**DOCUMENT 00 90 00
ADDENDUM**

ADDENDUM: 2

DATE: JANUARY 8, 2026

PROJECT: HOUSING AUTHORITY OF THE CITY OF LA CROSSE
2025 CAPITAL IMPROVEMENT PROJECTS
1307 BADGER STREET
LA CROSSE, WISCONSIN 54601
PROJECT NO. 25046

1 FIRST FLOOR LIGHTING PLAN
1/8" = 1'-0"

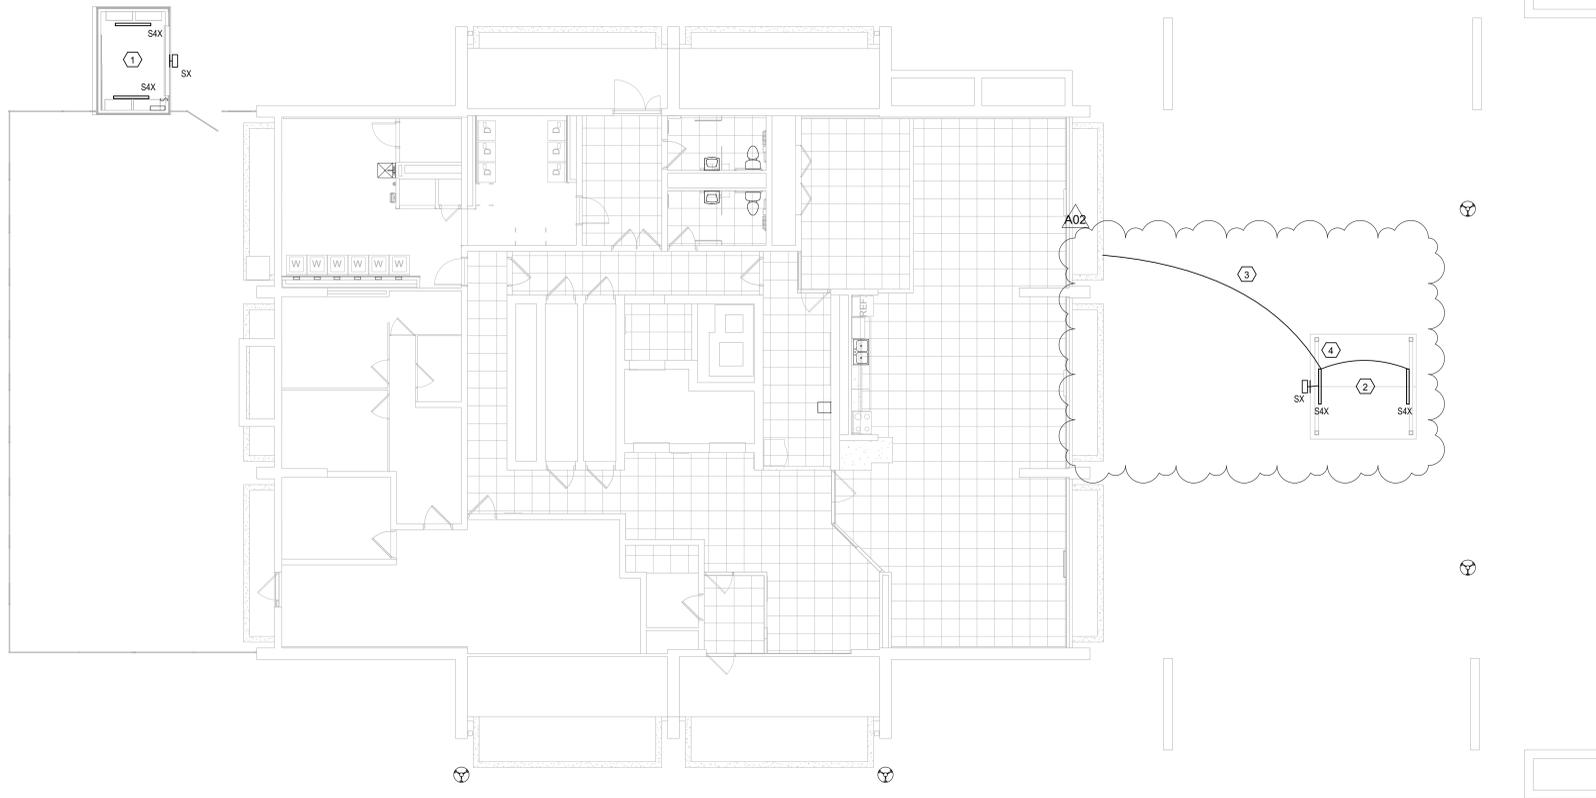
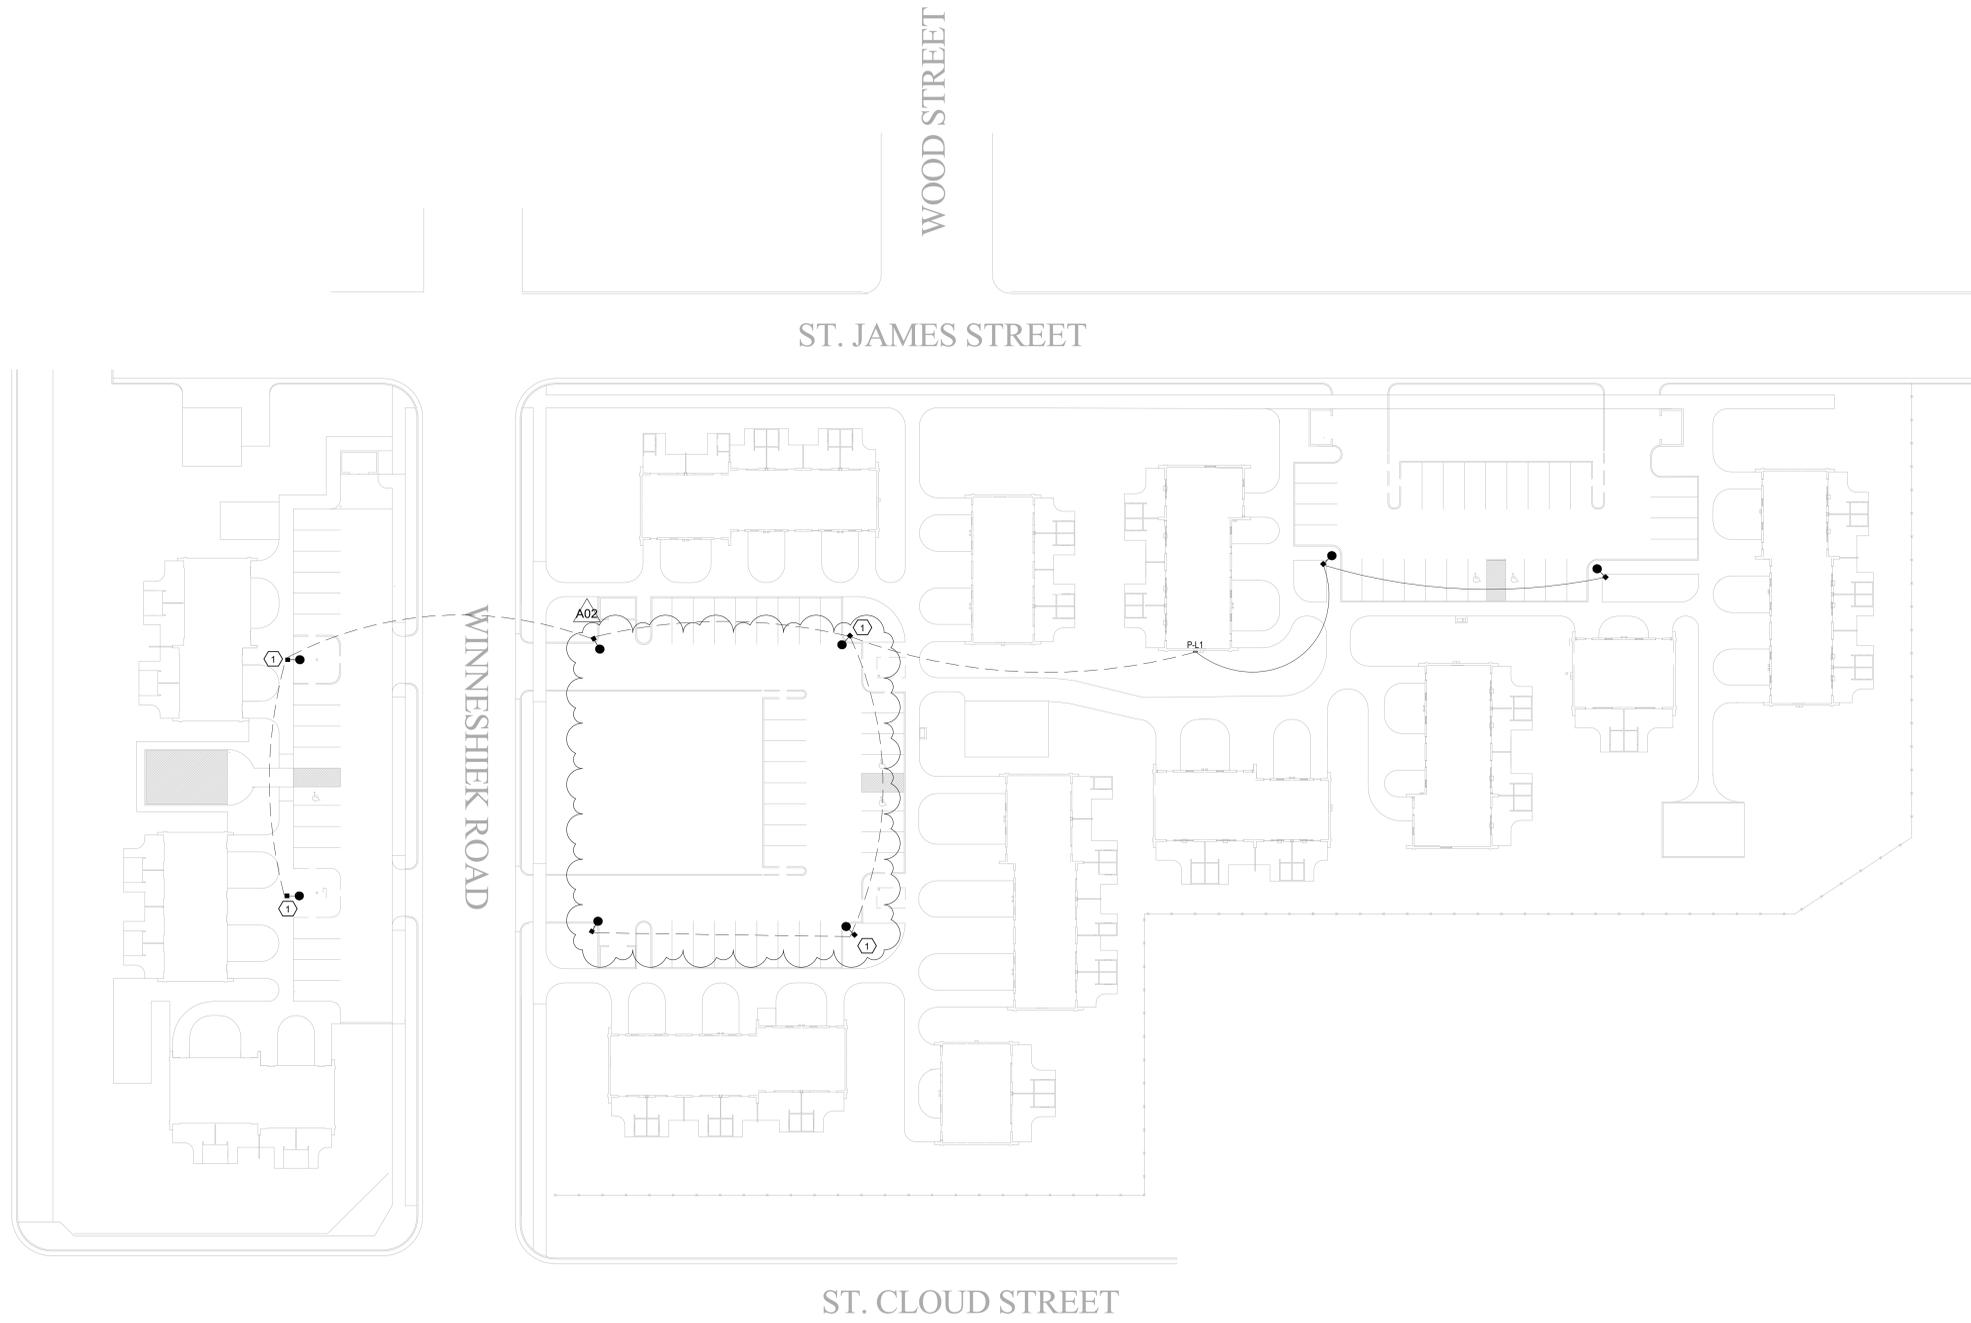
20. Sheet E520 first floor lighting plan 30"x42"

- a. See the revised sheet included in this addendum. Disregard the previous version.
- b. Revised lighting circuit source.
- c. Added and revised keynotes.
- d. Revised lighting fixture schedule.

ED601

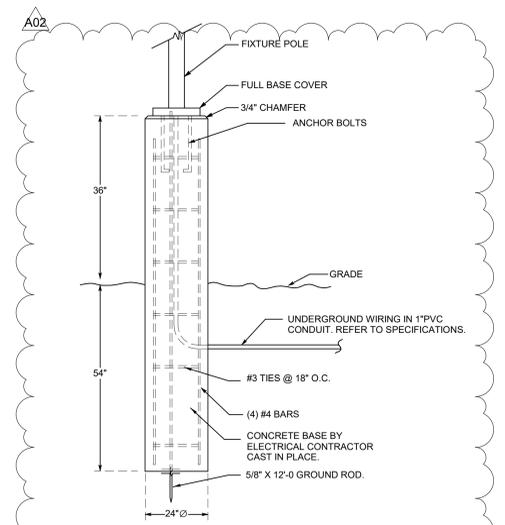
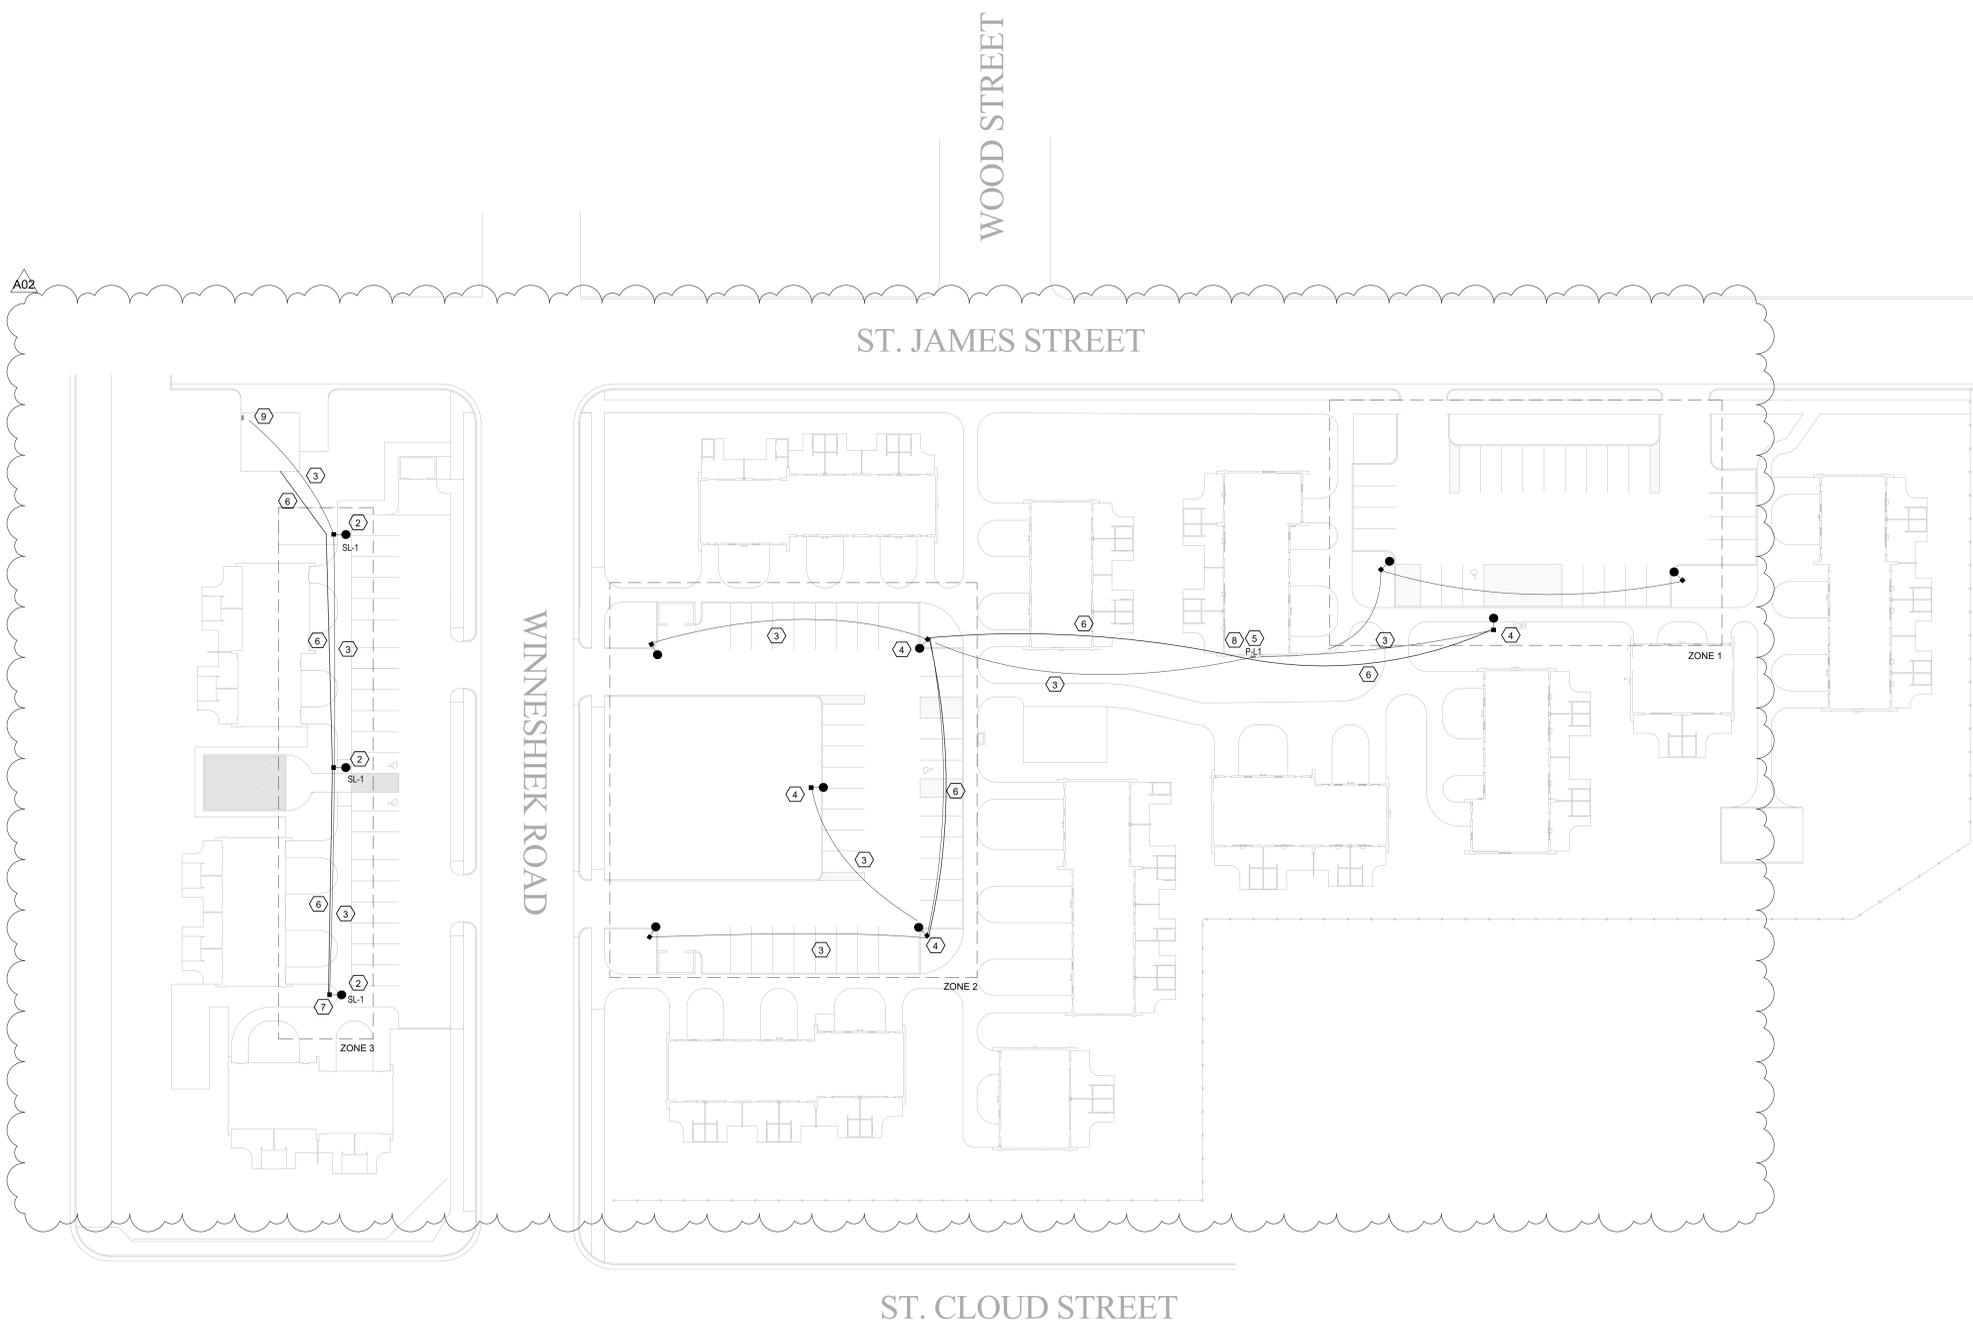
21. Sheet ED601 SITE DEMOLITION PLAN 30"x42"

- a. See the revised sheet included in this addendum. Disregard the previous version.
- b. Revised lighting circuit path.

3 NEMA 4 CABINET DETAIL
NTS

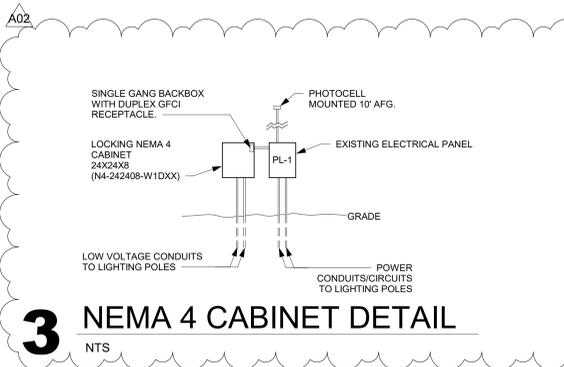
22. Sheet E601 SITE DEMOLITION PLAN 30"x42"

- a. See the revised sheet included in this addendum. Disregard the previous version.
- b. Revised detail #2.
- c. Revised site wiring runs.
- d. Added camera conduits.
- e. Added detail #3.
